Manitoba Hydro

Pointe du Bois Spillway Replacement

Alteration

August 2012

Figure:
8.3Ai

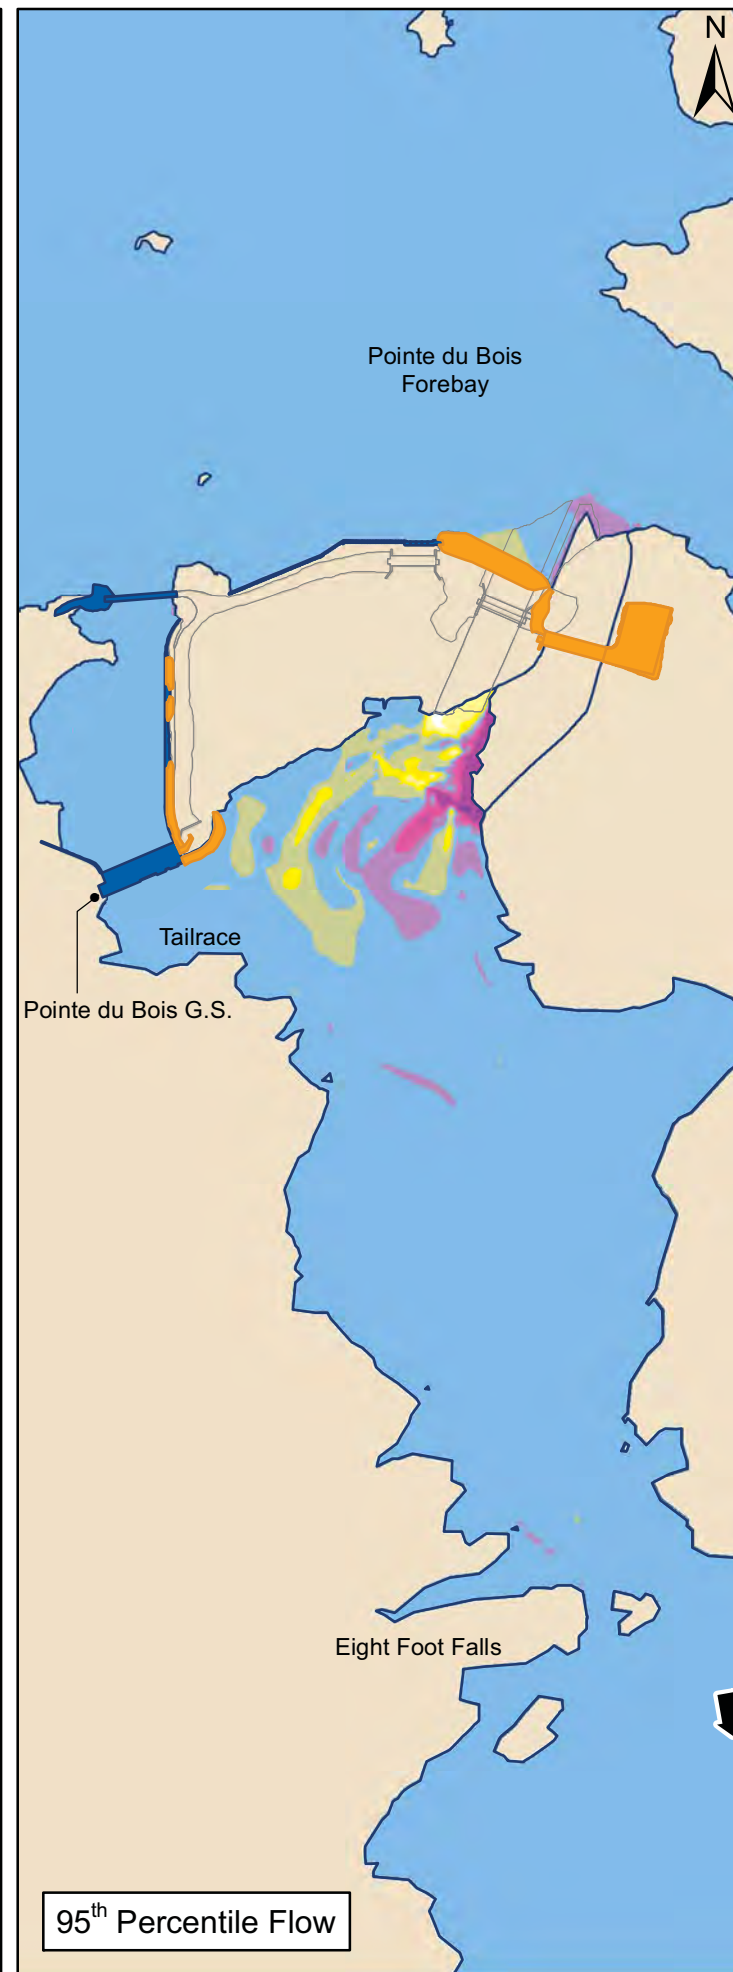
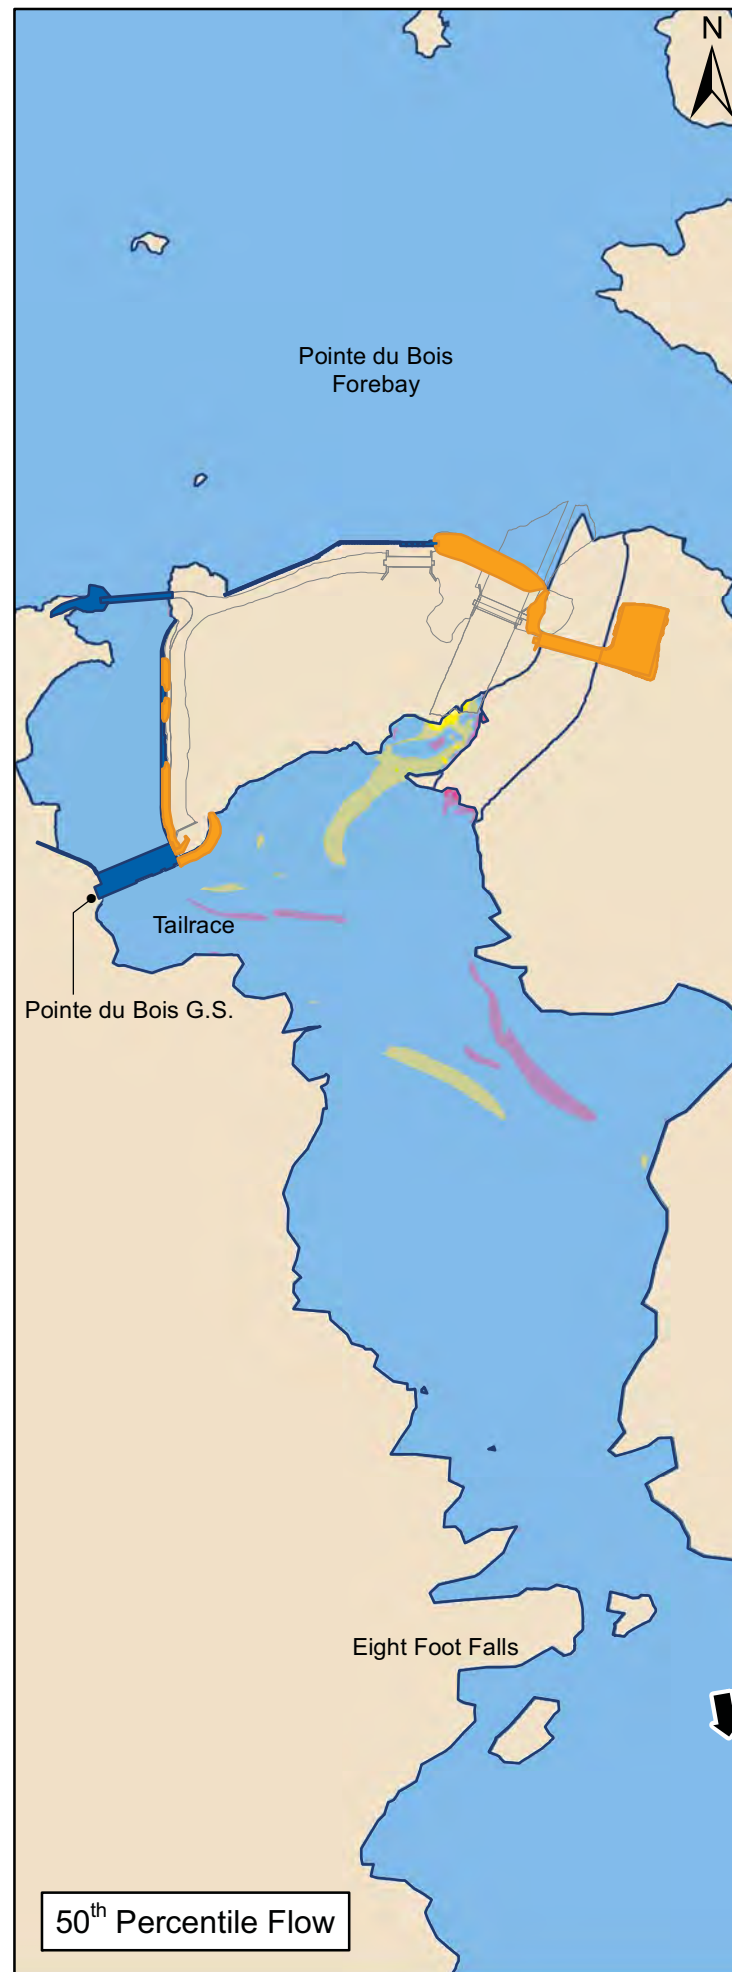
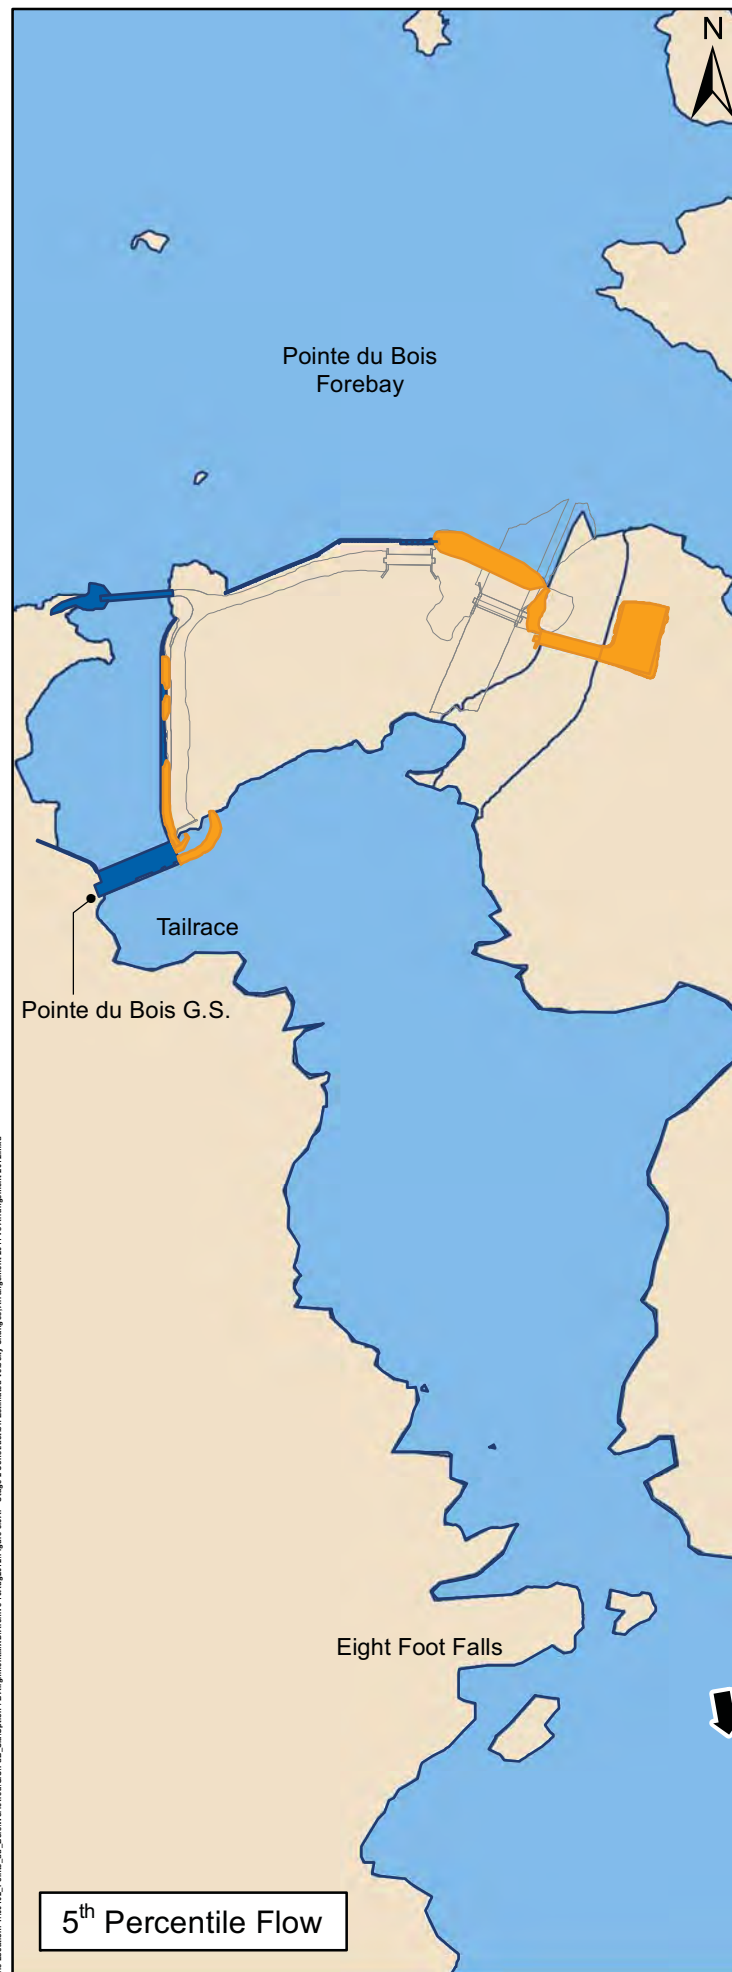
During Stage II construction, flows in excess of the powerhouse capacity will be passed through the new spillway. Water velocity changes upstream of the approach channel and existing spillway will be similar for both the Revised Arrangement and the Original Arrangement. Water velocities, flow patterns and depths during Stage II construction are shown in Figures 8.2A Rev1, 8.2B Rev1 and 8.2C Rev1. The estimated change to water velocities between existing conditions and Stage II construction (Revised Arrangement) is shown in Figure 8.3A Rev1. The estimated change to water velocities during Stage II Construction from the Original Arrangement and the Revised Arrangement is shown in Figure 8.3Ai.
